NON-CONCURRENCE PROCESS COVER PAGE

2. Title of Subject Document
SECY-22-XXXX, PROPOSED RULE: ALTERNATIVE PHYSICAL SECURITY REQUIREMENTS FOR ADVANCED REACTORS (RIN 3150-AK19)

3. ADAMS Accession Number
ML21334A004;ML21334A007

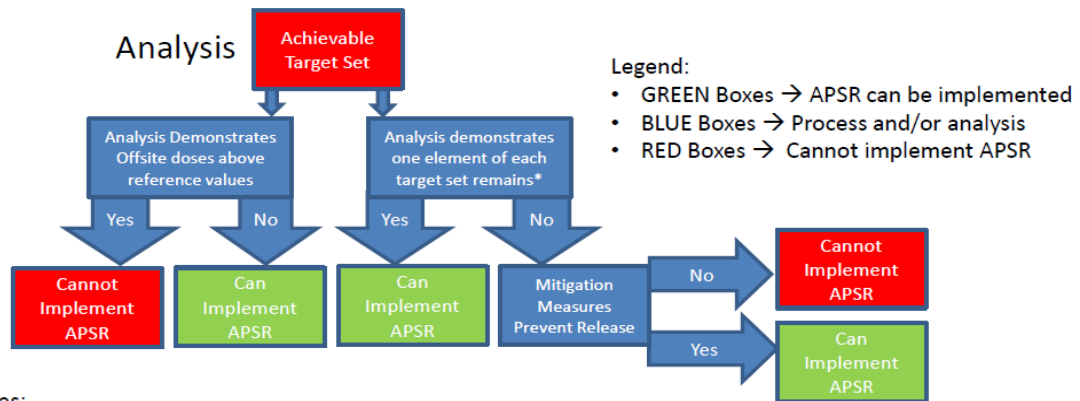
Contrary to the proposed rule, the Commission's current requirement in 10 CFR 73.55(r), which includes the necessary exemptions to prescribed requirements for implementing alternatives under 10 CFR 73.5, "Specific exemptions," does not require a licensee or applicant to perform an analysis to demonstrate that the consequences of a postulated radiological release resulting from a postulated security-initiated event do not exceed the offsite dose reference values defined in 10 CFR 50.34, "Contents of applications; technical information," and 10 CFR 52.79, "Contents of applications; technical information in final safety analysis report." Such an analysis to justify a request to implement an alternative is not required either under 10 CFR 73.55(r) or for the necessary exemption from prescribed security requirements in 10 CFR 73.55. Under the regulatory framework in 10 CFR 73.55, the technical basis must demonstrate that the alternative measure provides a level of protection that is equal to that of the corresponding specific requirement in 10 CFR 73.55 (i.e., the alternative meets the performance objectives and requirements in 10 CFR 73.55(b)). This justifies the implementation of the proposed alternative. The same technical basis justifies specific exemptions from prescribed security requirements that may be necessary to implement the alternative. This technical basis is the same as that required in the proposed rule, as the acceptability of the alternative is based on how the applicant or licensee would design and implement the alternative physical security requirements to meet the requirements of 10 CFR 73.55. This is evident from the proposed rule in 10 CFR 73.55(s)(1)(iii), which requires the licensee or applicant to demonstrate how it will meet the performance requirements in 10 CFR 73.55(b)(3) when using the selected alternatives.

Despite the similarities between the current and proposed rule, the proposed rule imposes the unnecessary burden that a licensee or applicant must perform consequence analyses. A consequence analysis for security-initiated events, based on the DBT of radiological sabotage defined in 10 CFR 73.1 (i.e., intentional acts that target structures, systems, and components (SSCs) and barriers), is given as an acceptable way for an applicant or licensee to meet the condition for eligibility to implement alternative physical security requirements in the design of its physical protection program. This is an unnecessary impediment for advanced reactor licensees or applicants because they could request implementation of the same alternative physical security requirements through 10 CFR 73.55(r) without performing any consequence analyses. Therefore, the differing view is that the proposed rule imposes an unnecessary burden on advanced reactor designers, licensees, and applicants that are considering and applying alternatives in their physical protection program designs. By issuing the proposed rule, the NRC could impede the efficient industrywide adoption of alternative means and methods, including innovative approaches, in the designs of physical protection programs for advanced reactors.

Furthermore, the analysis required by 10 CFR 73.55(s)(1)(ii) and 10 CFR 73.55(s)(1)(iv), as shown in the figure above, will allow a licensee or applicant to undermine the current safety and security regulatory framework. Specifically, a licensee or applicant could evaluate the potential offsite consequences of a loss of identified design features, SSCs, or barriers (e.g., those identified through safety analysis, assessments, and evaluations using reference values, the DBA, etc.) due to a DBT-initiated event, based on availability of mitigation equipment and ability to move freely to perform mitigation to prevent release up to an offsite dose of 25 rem. By establishing a provision in 10 CFR 73.55 that allows for reliance on mitigation measures (human actions) to prevent release, the NRC would enable licensees and applicants to intentionally erode current safety and security standards. Differing Views No. 2 and No. 3 of this enclosure address this point in more detail.

DIFFERING VIEW NO. 3a

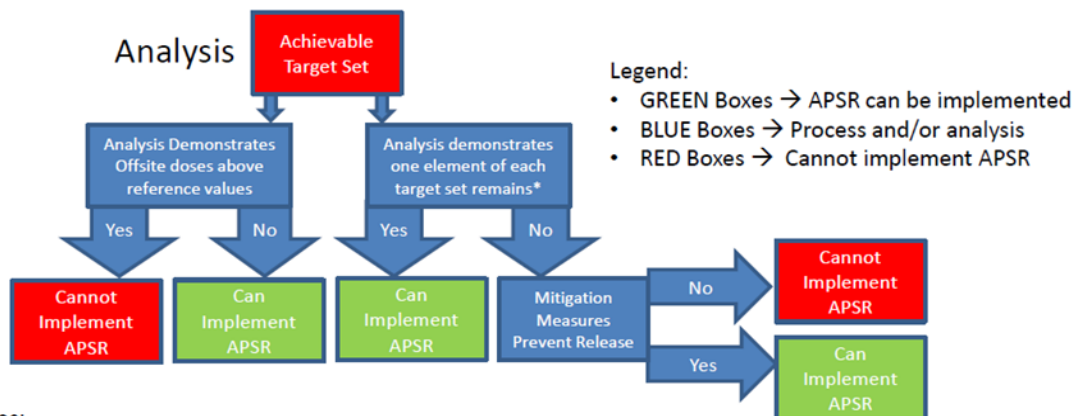
The implementation of 10 CFR 73.55(s)(1)(ii) and 10 CFR 73.55(s)(1)(iv) is contrary to the Commission’s expectation, established in the Policy Statement on the Regulation of Advanced Reactors (Volume 73 of the *Federal Register*, page 60612; October 14, 2008), that advanced reactor designs should include reduced reliance on human actions.

As stated earlier, this illustration was presented during public meetings on October 19, 2021, and January 20, 2022. It shows how the implementation of the proposed rule would allow for a licensee or applicant, through analysis performed under the proposed rule, to substitute mitigation measures relying on human actions for plant features, SSCs, and barriers identified through safety analyses, assessments, and evaluations in the safety and design bases. For example, under the proposed rule, the SSCs and barriers maintaining core cooling or containment integrity and spent fuel cooling or spent fuel pool integrity may be eliminated if analysis shows that mitigation measures can prevent any release resulting in a dose above 25 rem.

In addition, the illustration shows how the proposed rule undermines the current safety and security regulatory framework by allowing a licensee or applicant to downgrade the categorization, and the associated treatment, of SSCs and barriers based on 10 CFR 50.69. That is, under the proposed rule, a licensee or applicant may show that with mitigation measures, the failure of certain SSCs and barriers that are currently classified as RISC-1 or RISC-2 (or whose failure would lead to common-cause failure of RISC-1 or RISC-2 SSCs) would result in offsite release of no more than 25 rem. The licensee could then reclassify these SSCs and barriers as RISC-3 or RISC-4 or eliminate them altogether, considering them unnecessary for ensuring low risk of offsite release, although they are considered necessary under current design requirements for safety.

In relation to the safety/security interface, the implementation of the proposed rule allows the licensee or applicant to use a consequence analysis, based on consequences mitigated by reliance on human actions, to justify reducing the plant security posture, eliminating the protection of SSCs and barriers that otherwise would have been identified as target set equipment and protected by the design of the physical protection program. It should be noted that mitigation measures would be applied within a defense-in-depth strategy, to provide sufficient margin in safety and security designs to account for the uncertainties in the risk of public exposure to radiation resulting from design-basis accidents and beyond-design-basis events (e.g., aircraft impacts, Fukushima Dai-ichi event, and the DBT of radiological sabotage).

DIFFERING VIEW NO. 3b

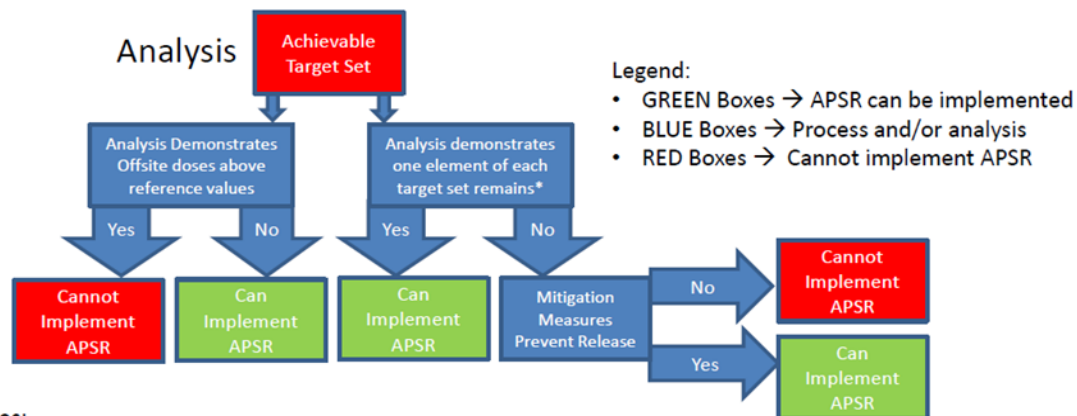
The proposed rule, at 10 CFR 73.55(s)(1)(ii) and (iv), introduces a more specific requirement for consequence analysis in 10 CFR 73.55 and provides a regulatory pathway for circumventing requirements established in the current safety and security framework for power reactors.
